CITY OF VALDEZ
Project Title: New Well 5 Pumping Station
Project No.: 21-310-2538
Contract No.: 2406

TO: All Recipients
SUBJECT: Addendum No.5

Date: November 12, 2025

VALDEZ WELL HOUSE #5 QUESTIONS AND ANSWERS

BY : **SHEET C8 OF 8** SHEETS
DATE
SCALE

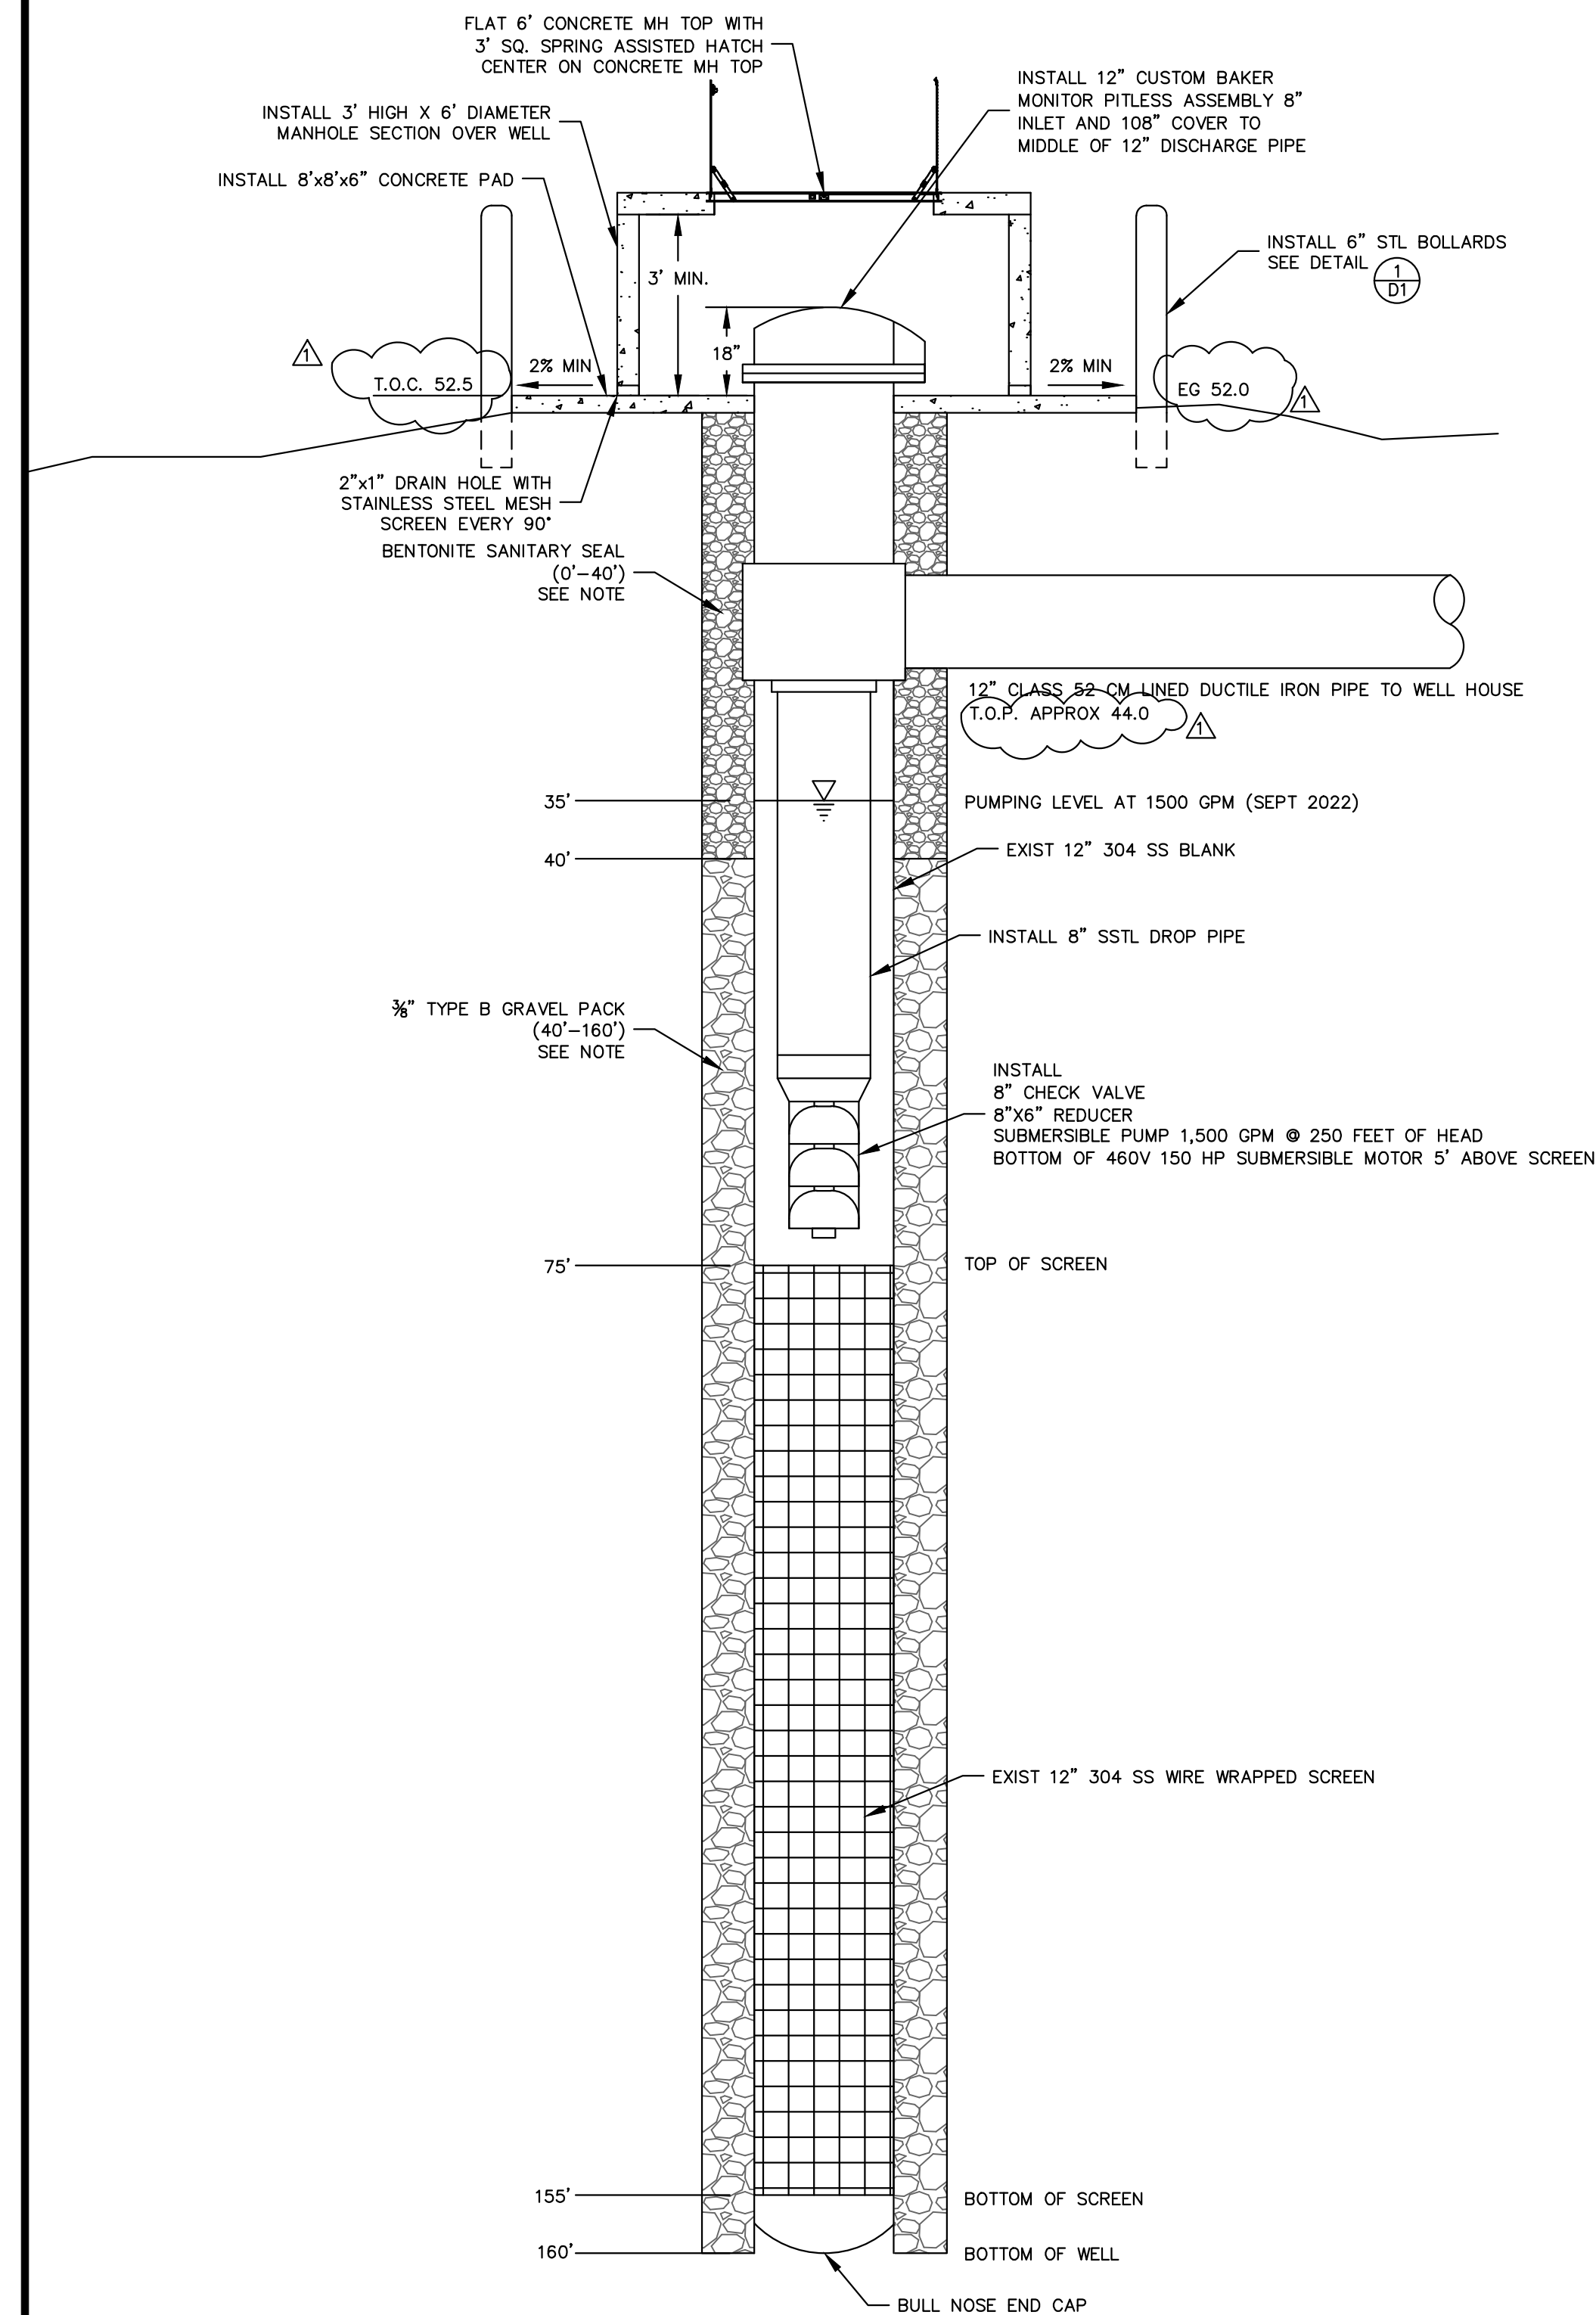
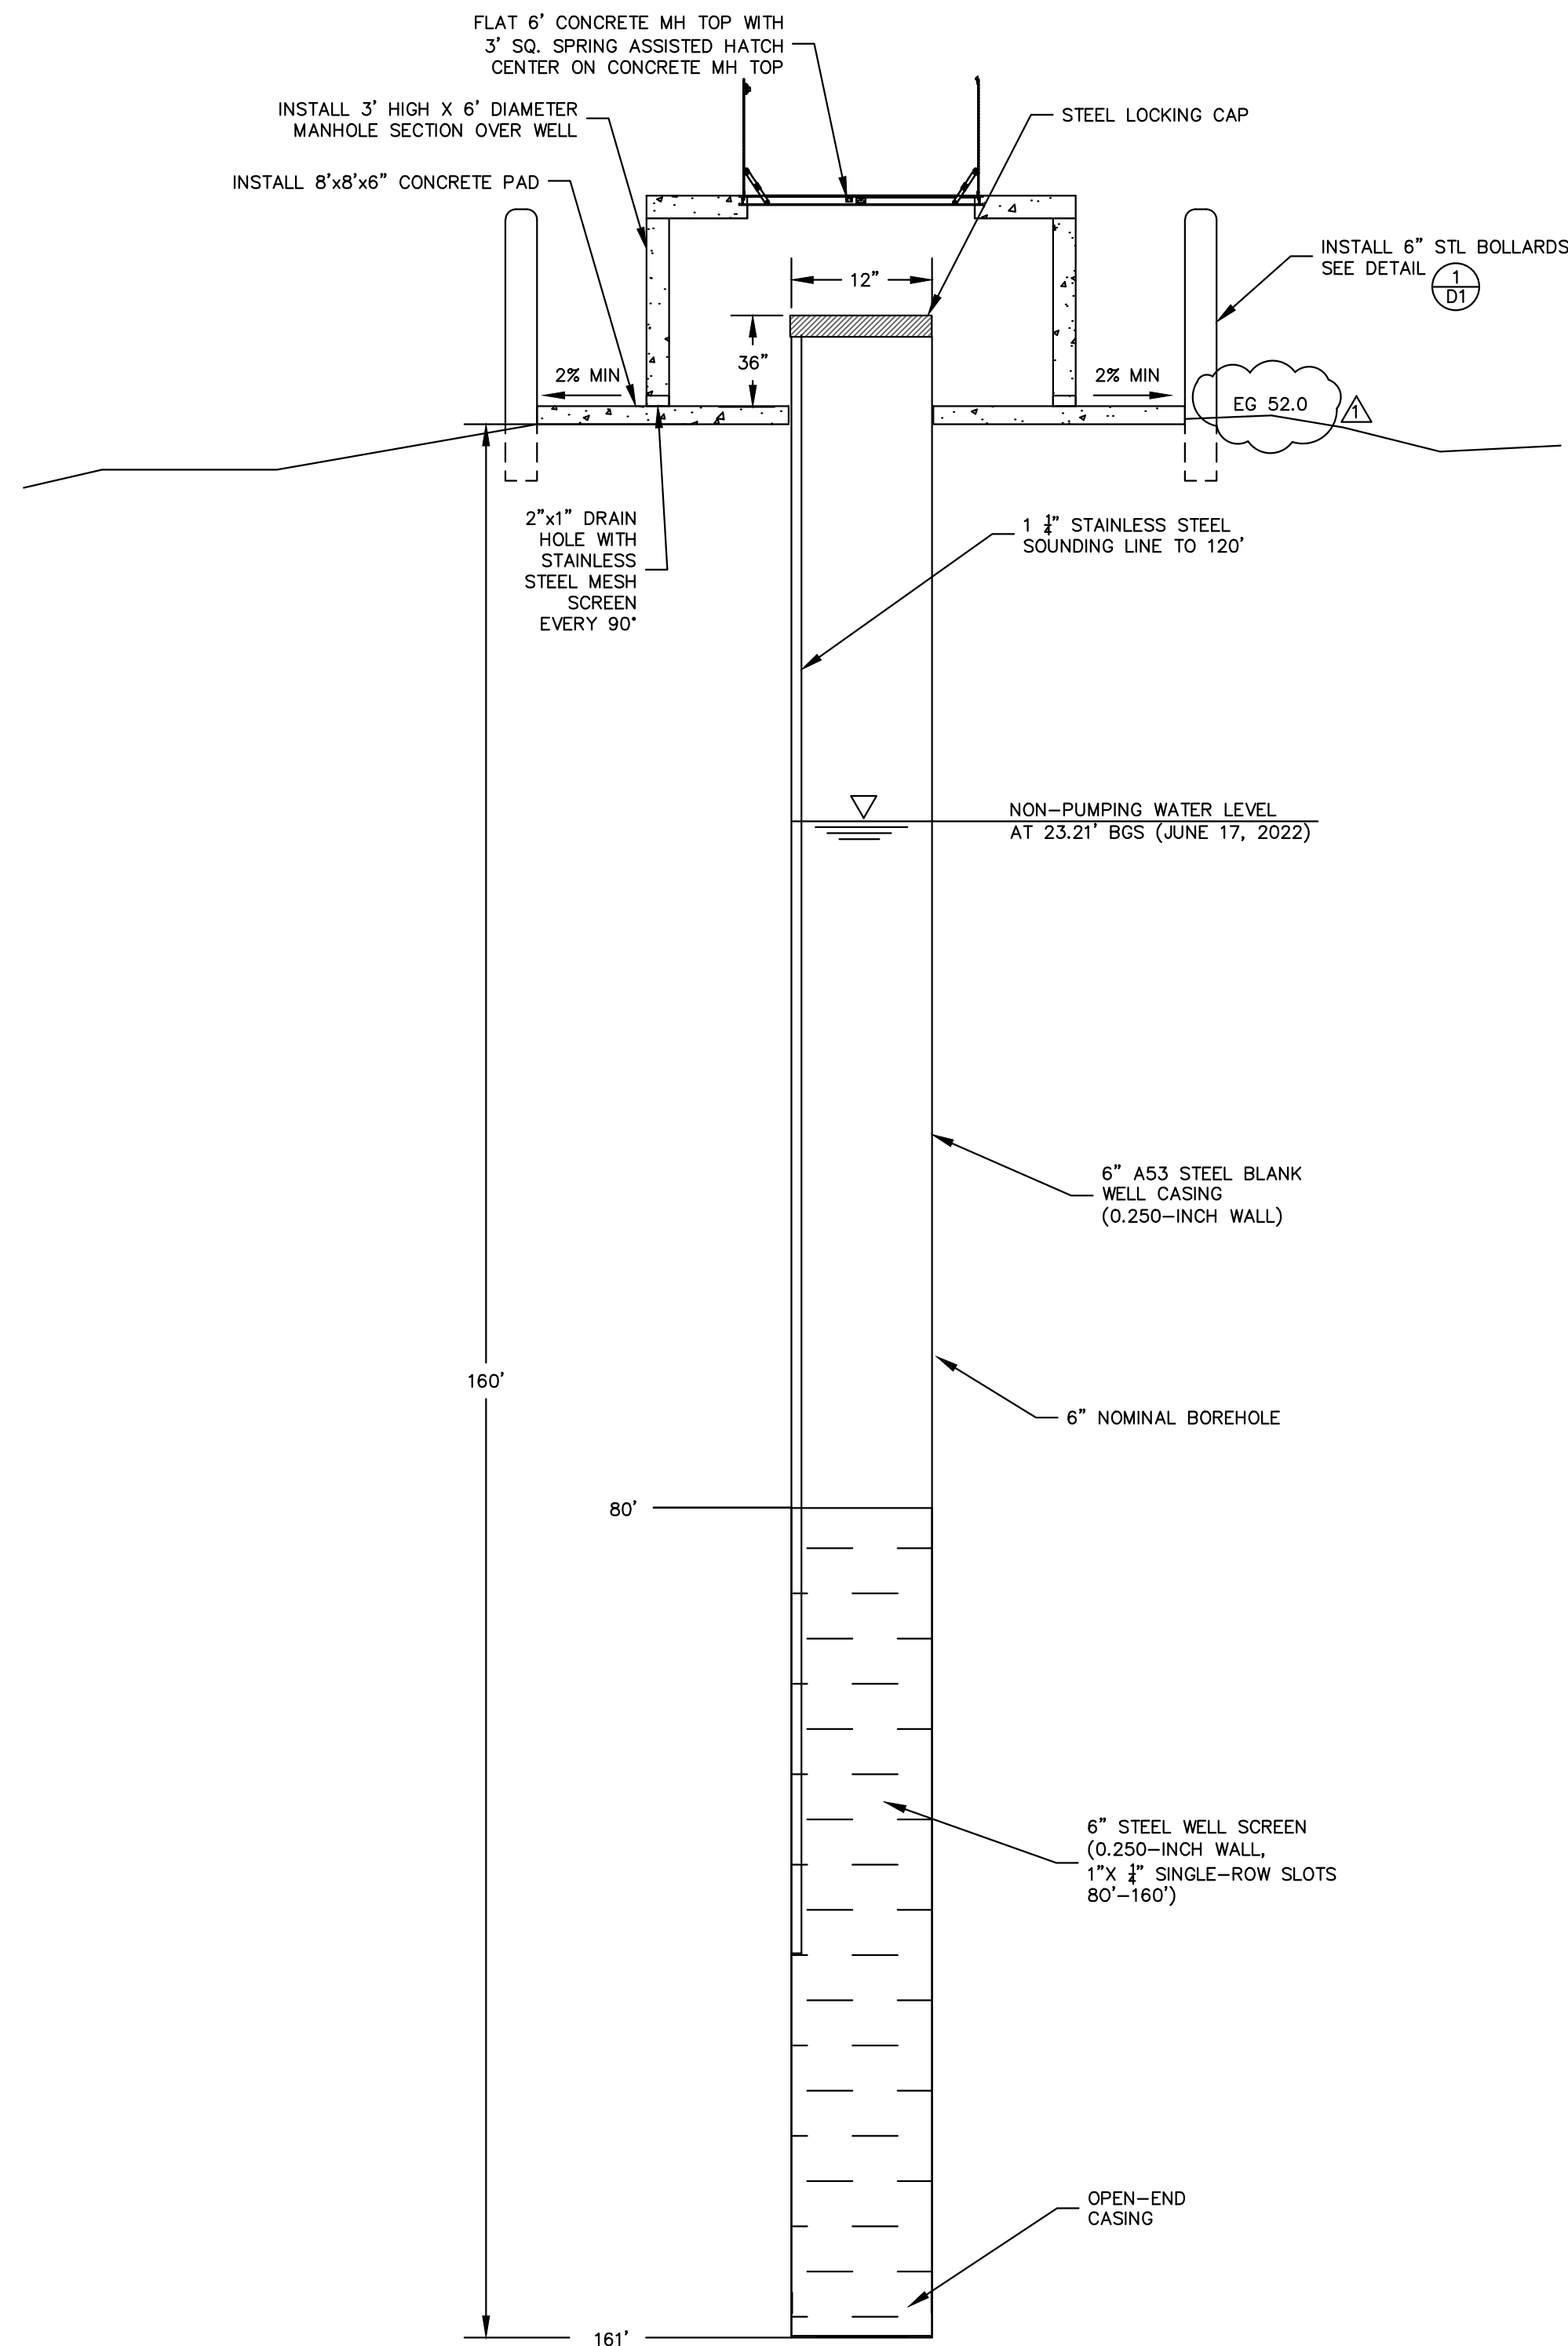
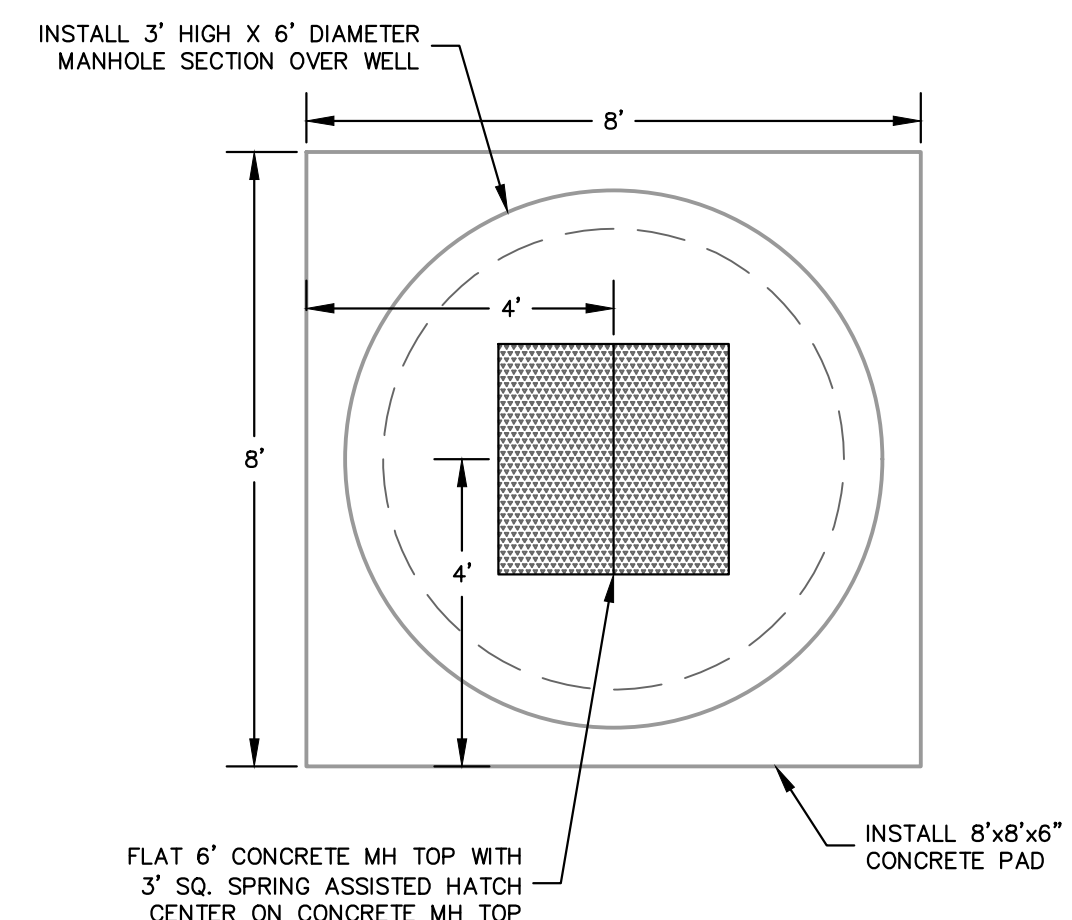
10. **Question:** The plans are vague regarding I.E., of the new or existing piping. If available, can you please provide the elevations of the existing waterlines or as-builts?

Answer: See attached proposed and existing pipe elevations on the revised plans. The elevations are clouded on sheets C5, C8 and D1.

10/31/2025	MU	ELEVATIONS ADDED
APPROVAL	REV	DATE	BY REVISION
